ADDENDUM NO. 2

**FOREST PARK PARKWAY
OVER METROLINK BRIDGE REPLACEMENT**

DATE: **7/26/2016**
LETTING NUMBER: **8615**

MSE WALL DETAILS	DATE	REVISION	DWN. BY	APPD. BY
	DATE		AMO	EBD
	APRIL 2016			
	SCALE:			
	NOT TO SCALE			
	PROJ. NO:			
	SC15-490			
	DWG. NO:			
	B-5

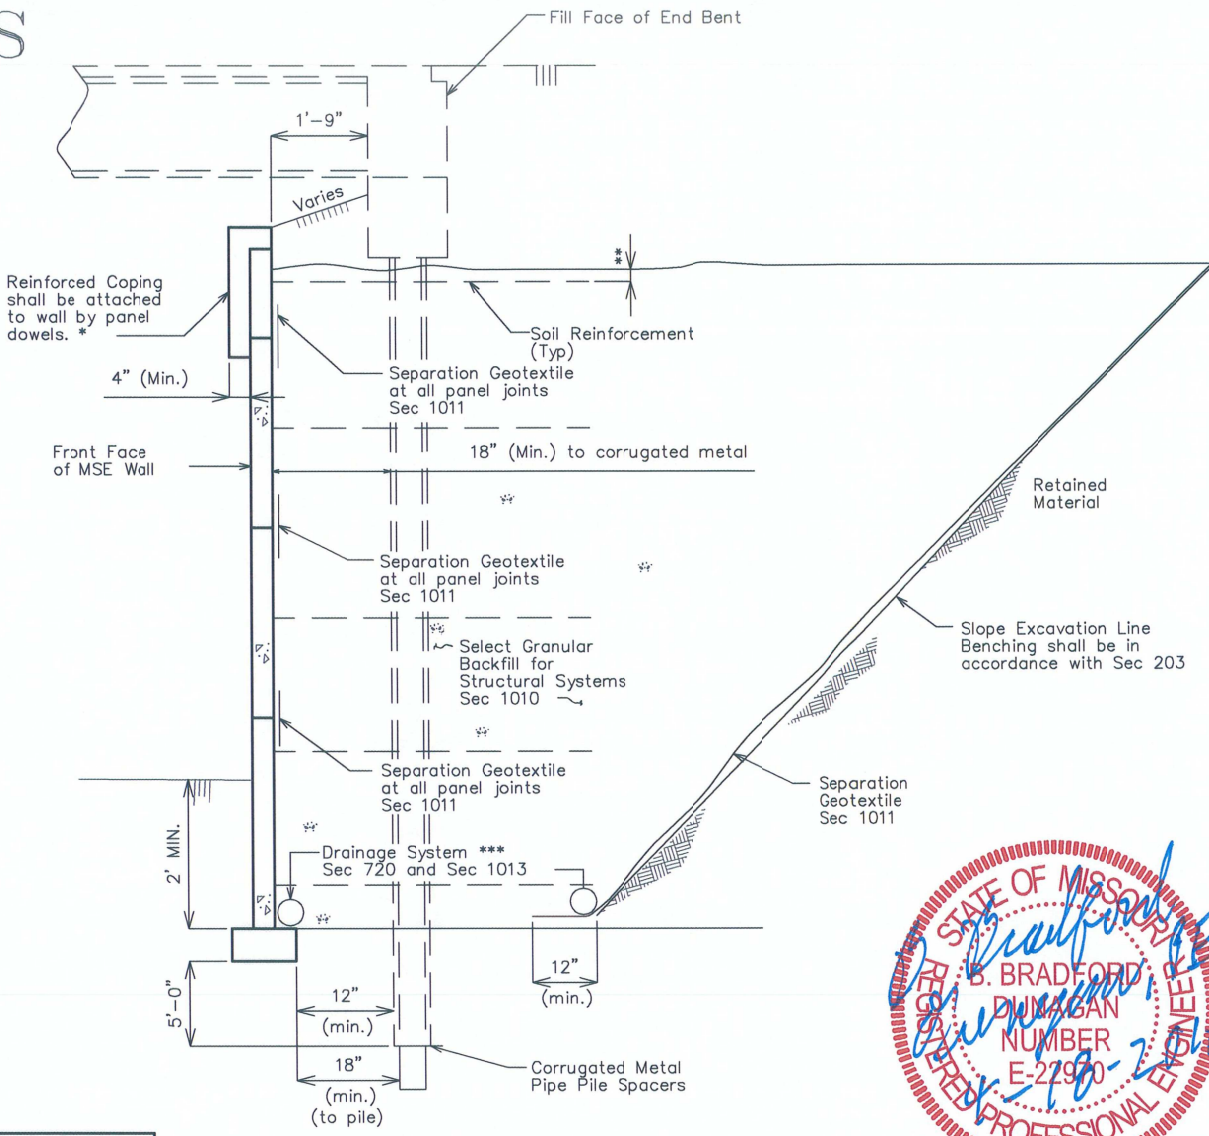
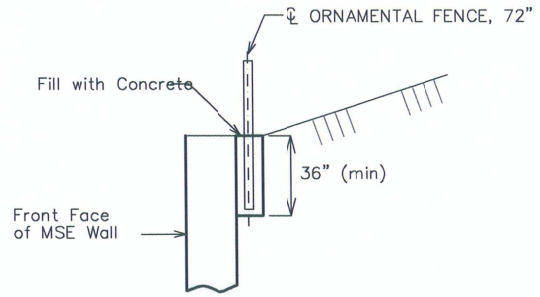
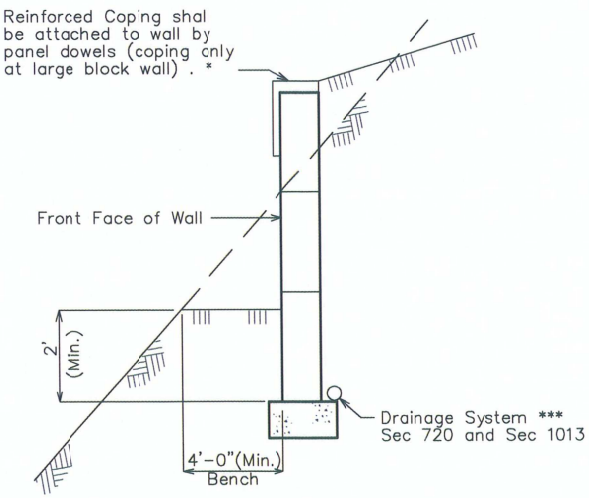
Add the following note to sheet B-5. "The design and installation of the MSE Wall system, including the design and implementation of any subgrade improvements required for the chosen wall system, are to be included in the contract unit price for the "Mechanically Stabilized Earth Wall System"."

THE DESIGN AND INSTALLATION OF THE MSE WALL SYSTEM,
INCLUDING THE DESIGN AND IMPLEMENTATION OF ANY SUB-
GRADE IMPROVEMENTS REQUIRED FOR THE CHOSEN WALL
SYSTEM, ARE TO BE INCLUDED IN THE CONTRACT UNIT PRICE
FOR THE "MECHANICALLY STABILIZED EARTH WALL SYSTEM".
